<b>Subject:</b>  AUTO A/C BLOWS WARM AIR (CANADA/MEXICO)	<b>Bulletin No:</b> 07-004/16
	<b>Last Issued:</b> 12/12/2016

2016-2017 CX-3 **Mexico and Canada** vehicles with VINs lower than JM1 DK \*\*\*\*\* 153364 (produced before September 5, 2016)

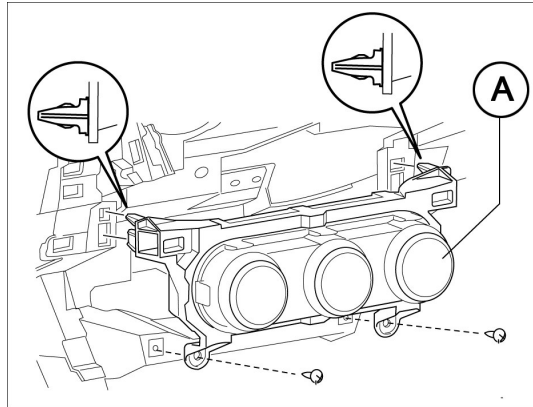
- The cabin temperature does not decrease to the customers desire (i.e. the set temperature on the temperature control dial). It is warmer in the vehicle cabin than the selected temperature.
- Even if adjusting the set temperature on the temperature control dial to decrease the cabin temperature, the air conditioner always blows warm air from the vents.
- When the outside temperature is approximately 50 degrees Fahrenheit (10 Celsius) as the seasons change, the customer first sets the temperature control dial to 72 degrees Fahrenheit (22 Celsius) to warm up the cabin. After the cabin temperature increases too warm, the customer decreases the set temperature but the vent air temperature does not change as expected and remains too warm. If it is adjusted to "Max. Cold" then too much cold air blows out and it is difficult to adjust the cabin temperature.

The climate control unit logic has been changed to correct this concern.

1. Verify customer concern.
2. Replace the climate control unit (A). Refer to MS3 online CLIMATE CONTROL UNIT REMOVAL/INSTALLATION [FULL-AUTO AIR CONDITIONER].
